TYPE A WATER LICENCE APPLICATION

QZ09-092

**BELLEKENO MINE DEVELOPMENT
KENO HILL SILVER DISTRICT
YUKON**

**Re: Bellekeno Mine Water Licence Application QZ09-092,
Response to Review for Adequacy and Supplemental Information**

**BELLEKENO MINE PROJECT
TYPE A WATER LICENSE APPLICATION
REVISED FIGURE 3-1
SURFACE WATER QUALITY MONITORING STATIONS**

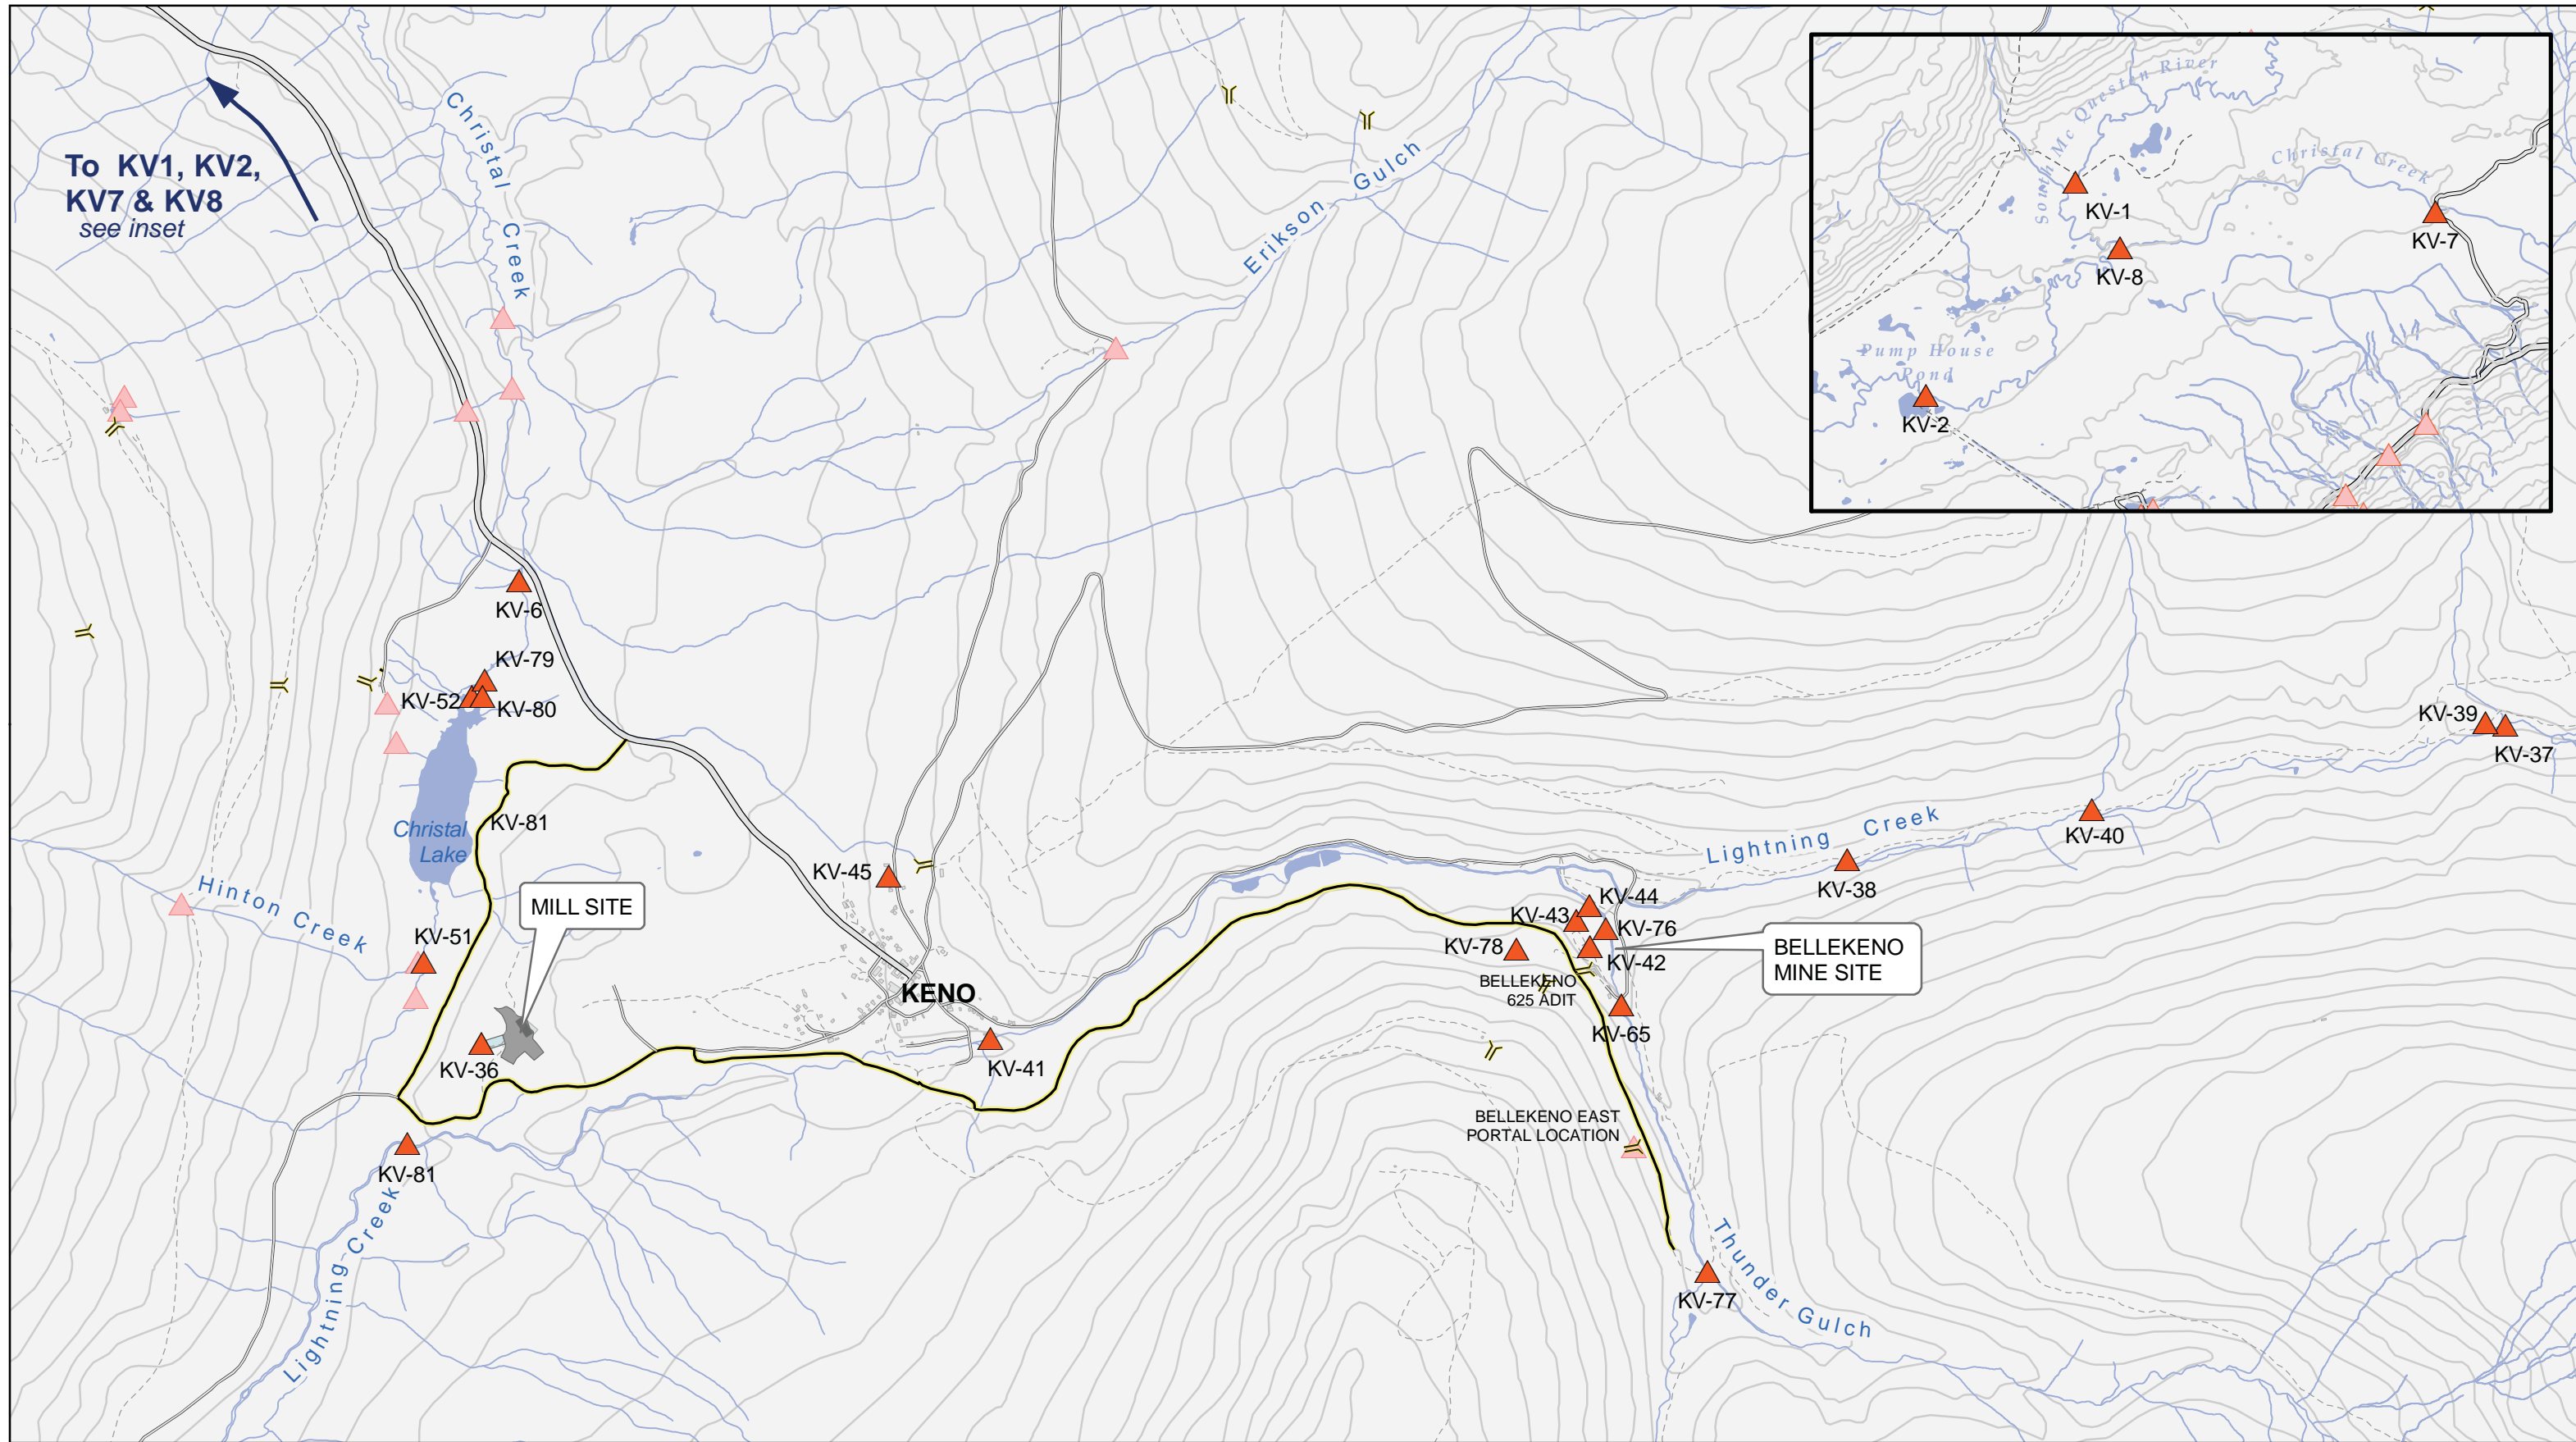
19. Please refer to the Main Application Report –Appendix J, figure 3-1 (exhibit 1.3.10). Monitoring stations KV-50 and KV-51 are described as being Christal Creek downstream of Hinton Creek and upstream of Hinton Creek respectively. Please confirm that the monitoring stations are correctly labeled.

When comparing figure 3-1 to figure 7-1 of the Main Application Report, it appears that Hinton Creek is inconsistently represented. Please update the figures where necessary.

Please refer to revised Figures 3-1 and 7-1 to the Main Application Report on pages 7 and 8 of these responses.
